Comment Report

Project Name: 2016-02 Modifications to CIP Standards | Concepts for Virtualization and Definitions
Comment Period Start Date: 10/6/2017
Comment Period End Date: 11/2/2017
Associated Ballots:

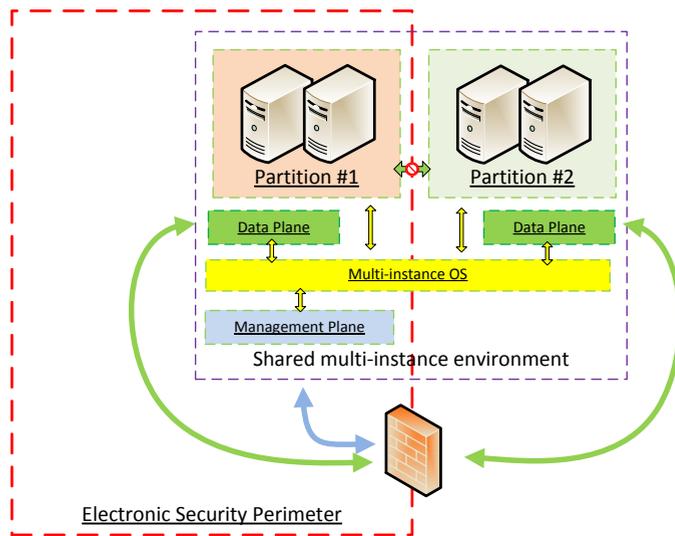
FMPA recommends that the SDT consider the scoping on this requirement part. Would this be identified in the applicability table since it only applies to multi-instance? At the top of the standard/requirement? Or as shown within the requirement? We recommend the SDT provide additional clarity on the ability to have technical controls for other layers (aside from the communication layer) and with shared memory space. We would also like the

SDT to consider the ramifications on the use of a cloud based SIEM vendor who is most likely using a virtualized environment. In the cloud environment, an entity would be transferring risk as well as trust
